CALIFORNIA COASTAL COMMISSION

STAFF REPORT: APPEAL

SUBSTANTIAL ISSUE

LOCAL GOVERNMENT:	County of Mendocino
DECISION:	Approval with Conditions
APPEAL NO.:	A-1-MEN-01-043
APPLICANT:	David and Suzanne Wright
PROJECT LOCATION:	45501 Headlands Drive, Little River, Mendocino County, APN 121-260-10.
PROJECT DESCRIPTION:	Construction of a 2,550-square-foot, 18-foot-high, single-family residence with a 625-square-foot detached garage, onsite sewage disposal system, extension of utilities, and installation of 2,500-square-feet of paving for a driveway.
APPELLANTS:	Wendy Weikel
SUBSTANTIVE FILE: DOCUMENTS	1) Mendocino County CDP No. 17-01; and 2) Mendocino County Local Coastal Program

PLAN REVISION

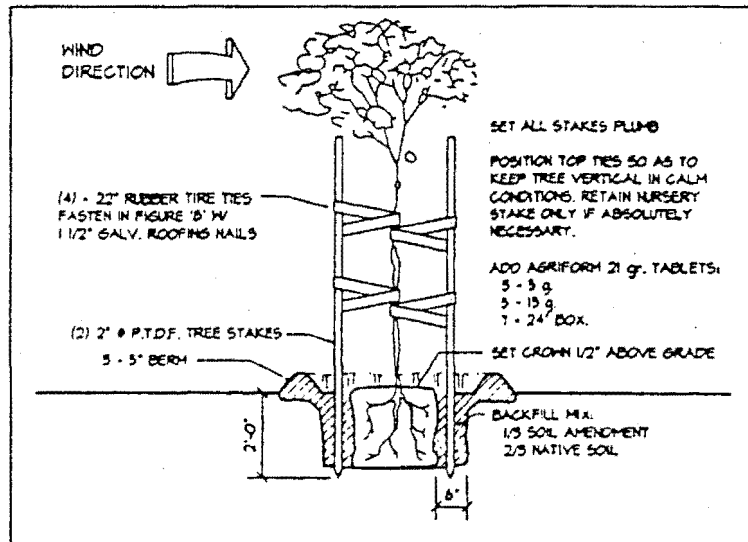
A revised landscape plan was submitted on June 14, 2001. It appears as though it would provide sufficient screening of the visible portion (from Highway One) of the residence. The landscape plan does not specifically identify the location of an irrigation system, but does provide detailed specifications in #6 of the landscaping notes. Special Condition #4 is recommended to require the applicant to adhere to the specifications contained on the landscape plan to ensure the plantings will be established and maintained in perpetuity. The landscape plan recommends the trees be planted a minimum of 20 feet from the bluff edge and the shrubs be planted a minimum of 15 feet from the bluff edge. The geotechnical investigation discussed in the "Hazards" section of this report concludes that the bluff should retreat approximately 20 feet over the course of 75 years. Therefore, the required landscape trees should provide screening of the residence from public view over its required minimum 75-year economic lifespan.

4. The revised landscaping plan submitted June 14, 2001 shall be implemented and maintained in full accordance with the notes/specifications provided with the plan (i.e. soil preparation, planting, staking and wind protection, irrigation, maintenance and replacement and protection of existing vegetation). The new trees shall be planted prior to

LOT 10
LITTLE RIVER
HEADLANDS
SUBDIVISION

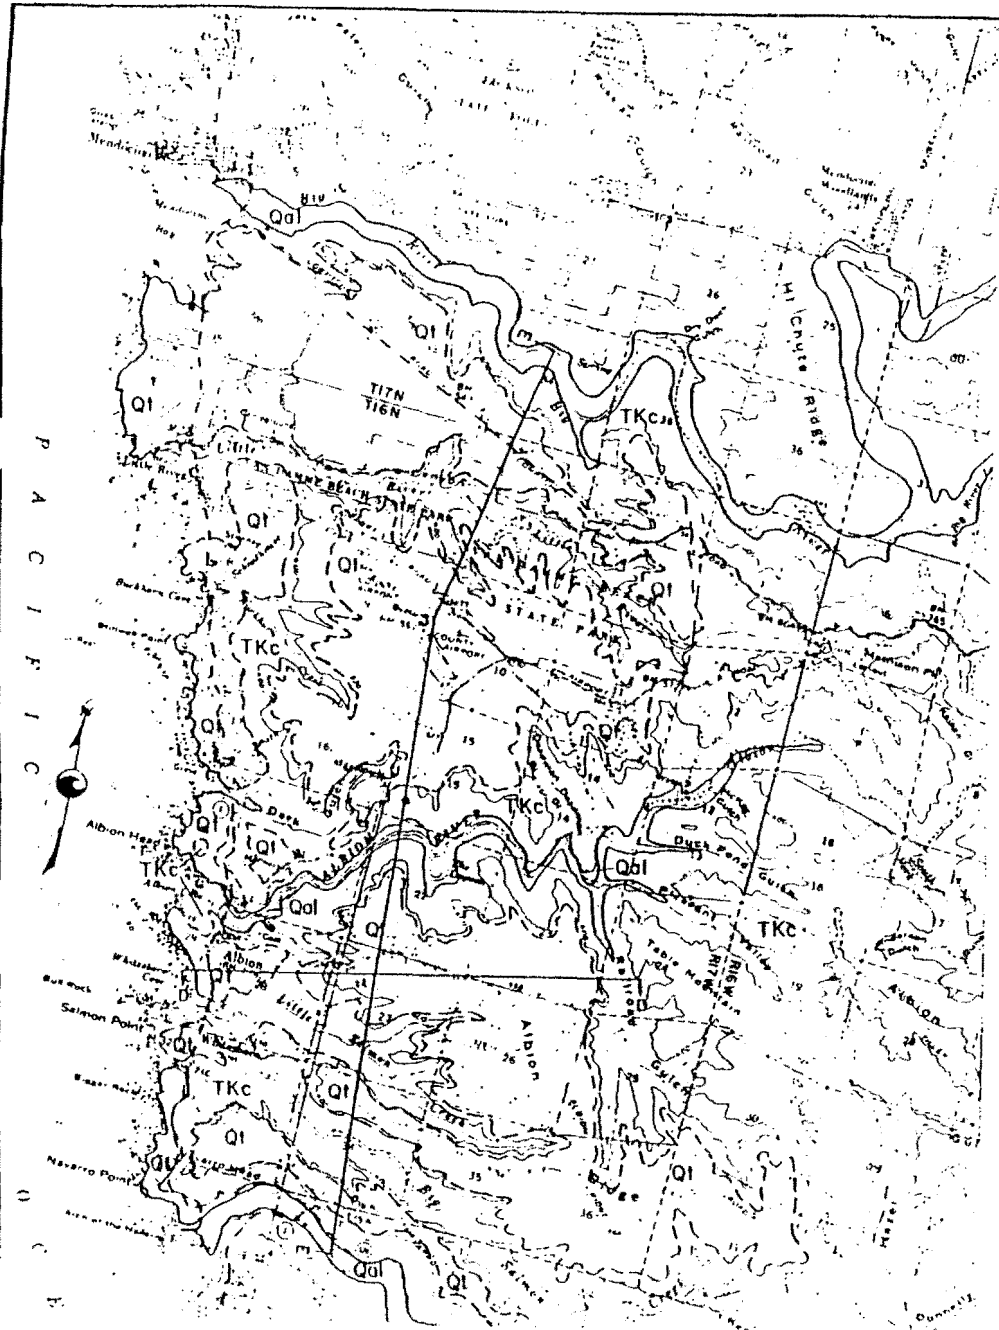
The appellant questions whether the stability assessment within the nearly eight-year-old geotechnical report adequately considered the hazards associated with current conditions on the bluff face or the presence of sea caves below the blufftop. The appellant submitted a photograph of a large rotational slump on the project site bluff face that appears to contradict data (see item no. 3, above) on which the Earth Mechanics report based its conclusions regarding site stability. In addition, the appellant provided copies of other geologic reports, one prepared for the project site (Bellarino, 1986) and another for nearby Lot No. 7 (J.R. Bovyer, 1985), as evidence of the paucity of the setback recommended in the Earth Mechanics report. Both of these earlier reports recommend building setbacks of between 50 to 85 feet from the blufftop edge.
